UNITED STATES PATENT AND TRADEMARK OFFICE

APPLICATION NO.	FILING DATE	FIRST NAMED INVENTOR	ATTORNEY DOCKET NO.	CONFIRMATION NO.
09/677,870	10/03/2000	Woo Hyuk Choi	2658-0240P	6124

Office Action Summary

DETAILED ACTION

FIG. 6

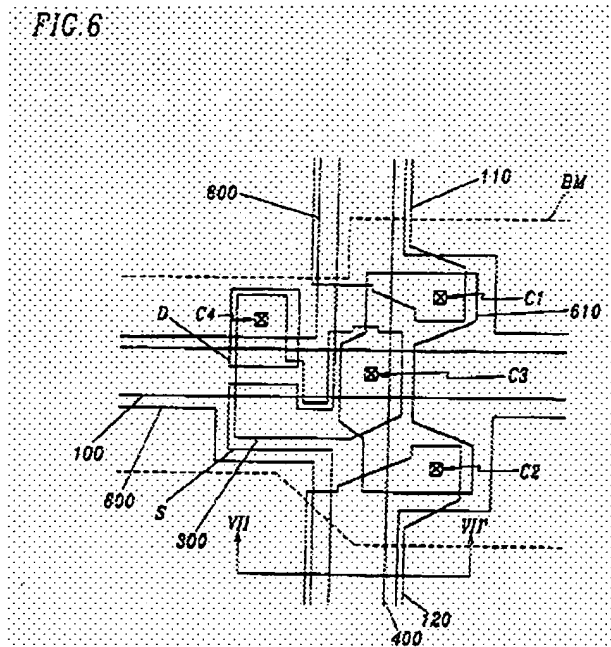
As to claims 1, 8, 10, 17, 21, and 23, Kim discloses in the third embodiment, Figures 6 and 7, (col. 6, line 35 through col. 7, line 5), a thin film transistor substrate in a liquid crystal display substrate comprising: a data line, 400, for applying a data signal, a gate line, 100, for applying a gate signal, and a transparent pixel electrode, 600, for driving a liquid crystal cell, repair lines, 110 and 120, (Applicant's gate dummy pattern) formed of the same material layer as the gate line (col. 6, lines 38-42 and col. 2, lines 10-17) and formed parallel to said data line, 100, and to overlap the pixel electrode, 600, and data line 400, to compensate for misalignment occurring along the data line,

Wherein the gate dummy pattern is formed to overlap [L3 and L4] with an edge portion of the pixel electrode (per Figures 6 and 7), and is separated by gate insulating layer, 200.

FIG. 7

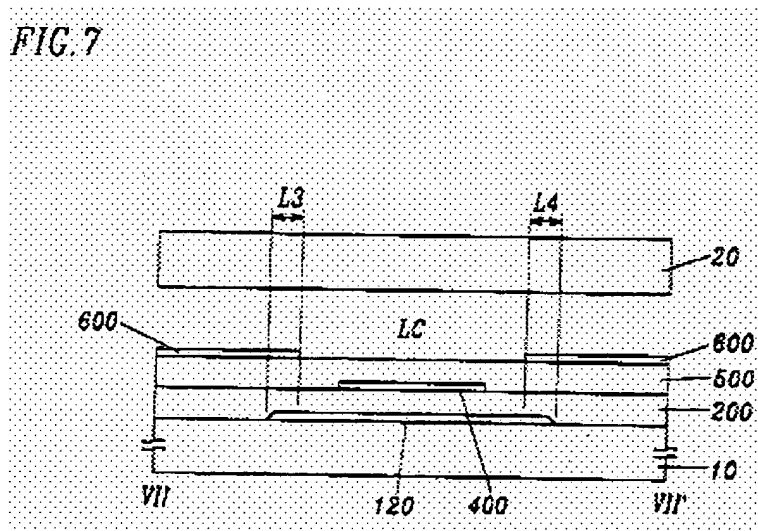
Kim does not explicitly disclose 2) overlap [L3 or L4] by 0.5-1 μm .

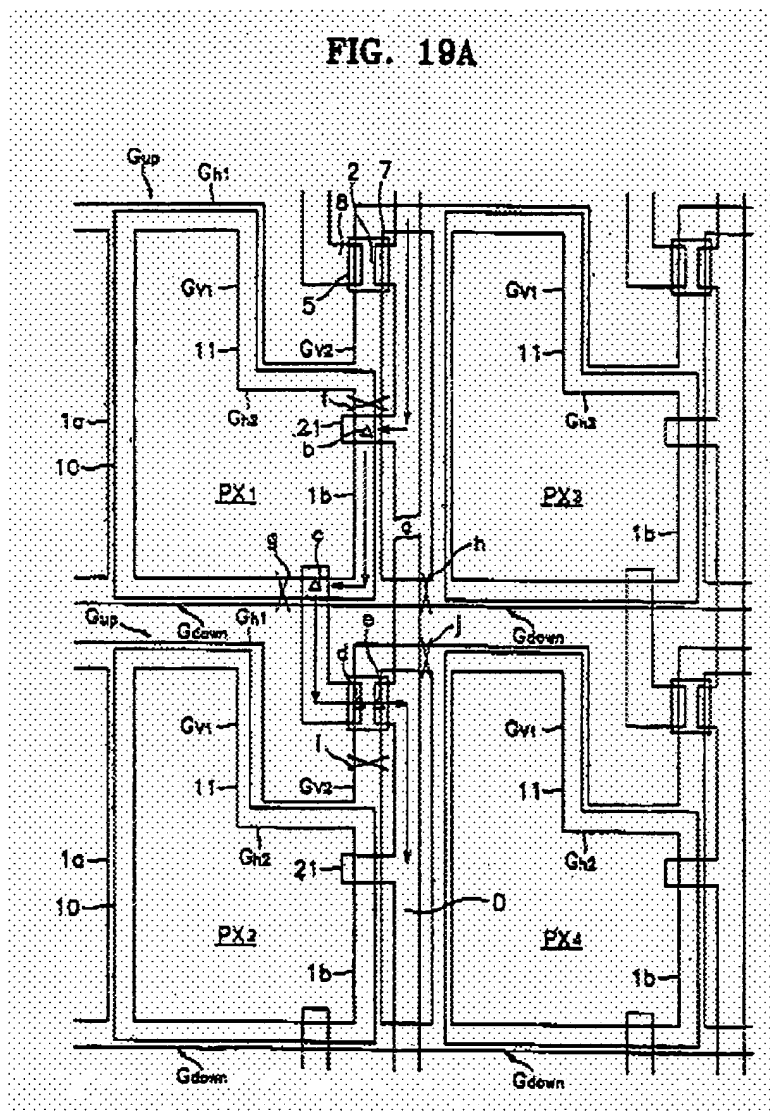
Song teaches 1) the use of a redundant pattern that is integrated with the gate line in Figure 19A (G_{up} and G_{down} or 1a and 1b) as a redundancy electrode for electrically connecting the gate line to the broken data line (col. 17, lines 4-67, especially col. 17, lines 47-54) to effect repairs.

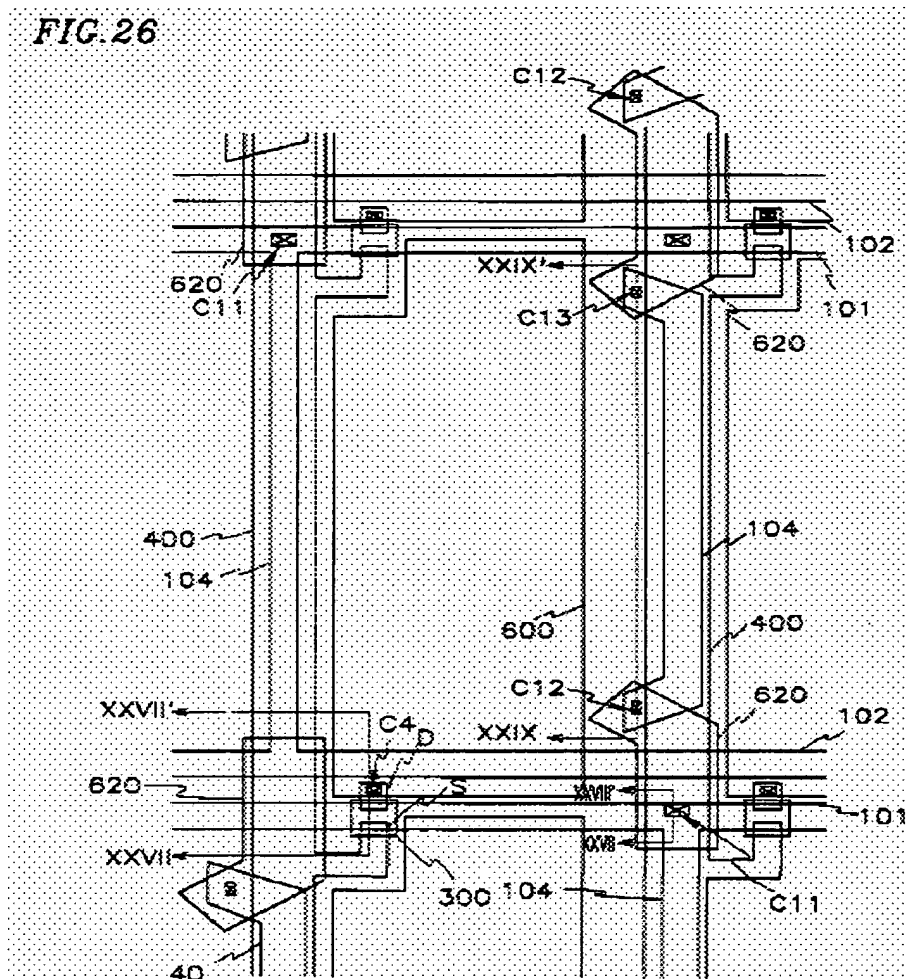
Kim teaches in Figure 13 wherein when the data line is broken, the use of forming holes and connections to the repair lines, 110 and 120, (Applicant's gate dummy pattern) and to a connecting pattern, 610, to repair a broken data line, 400, (col. 8, lines 1-15).

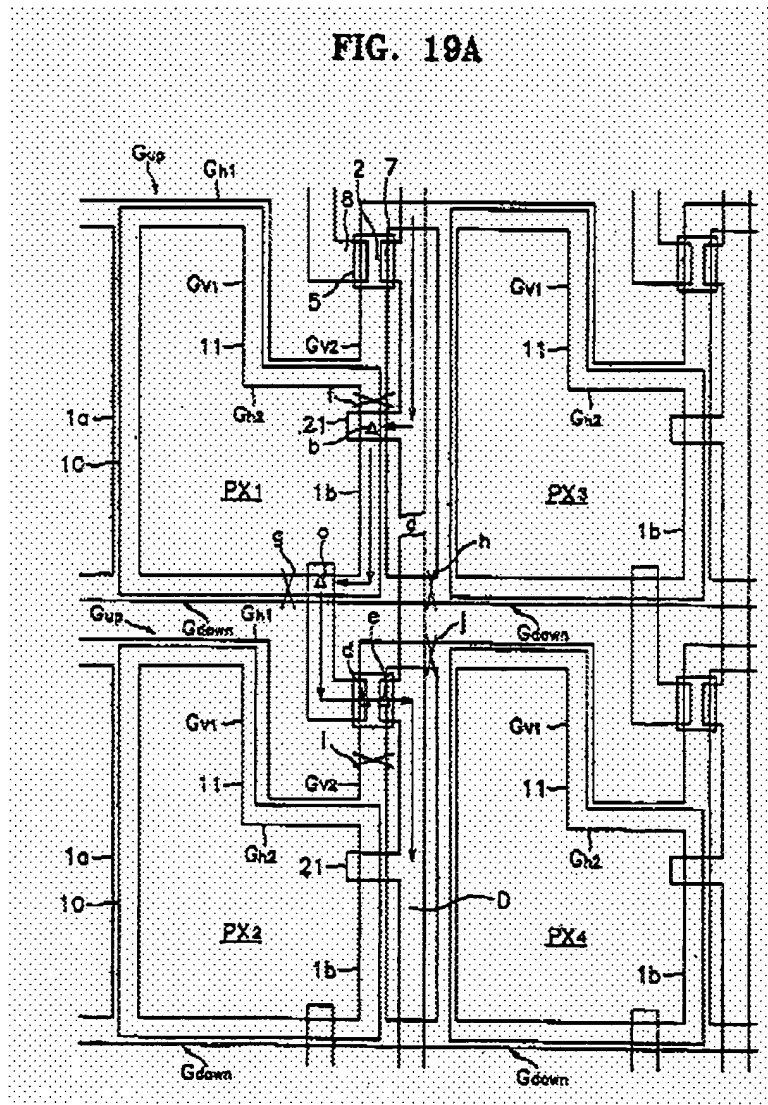
Song teaches, wherein when the data line is broken, the use of a redundant pattern in Figure 19A (G_{up} and G_{down} or 1a and 1b) as a redundancy electrode for electrically connecting the broken data line (col. 17, lines 4-67, especially col. 17, lines 47-54) to effect repairs.

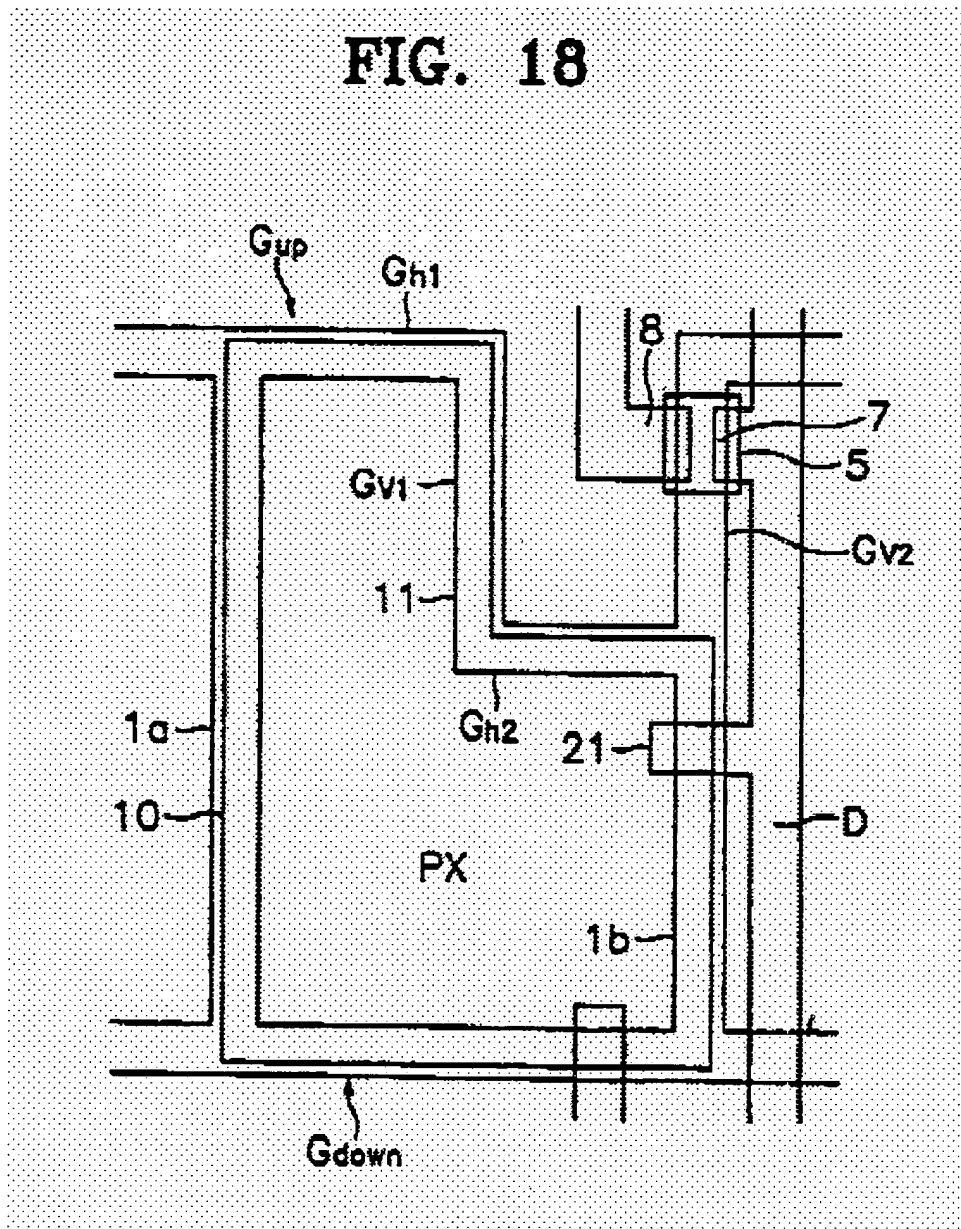
Kim in view of Song does not explicitly disclose a recess in the dummy pattern to make it easier to cut for purposes of repair, thereby disconnecting the gate dummy pattern from the gate line.

Irie teaches as prior art that a structure branching off the gate line may be made narrow (Applicant's recess), and not overlapping the data line, to facilitate laser cutting (col. 2, lines 7-20) for purposes of repair (col. 2, lines 61-67) which allows for easy correction of point defects.

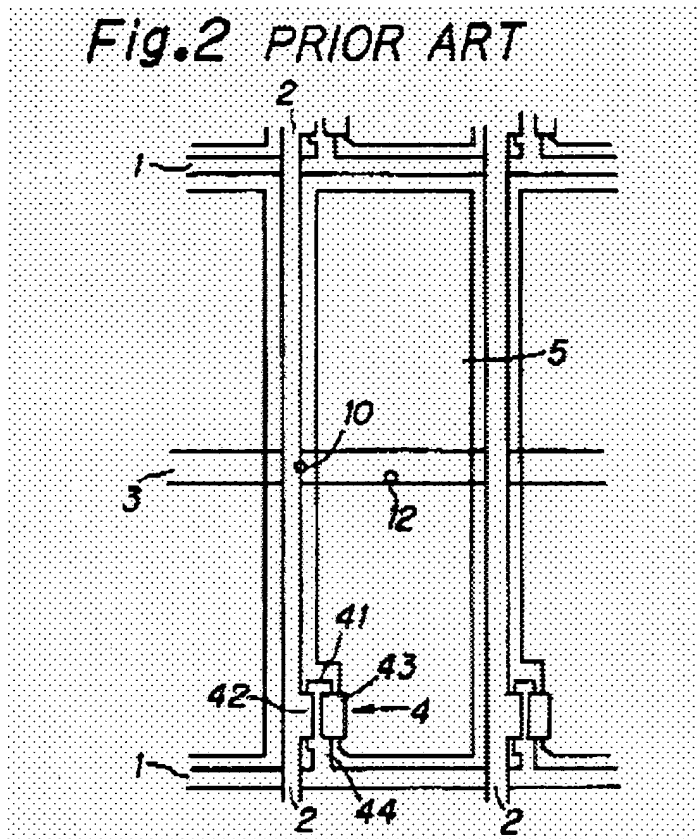
(5) It is respectfully pointed that recess is on the left side of the narrow part, 44, that leads to the gate electrode, 41, in Figure 2 below:
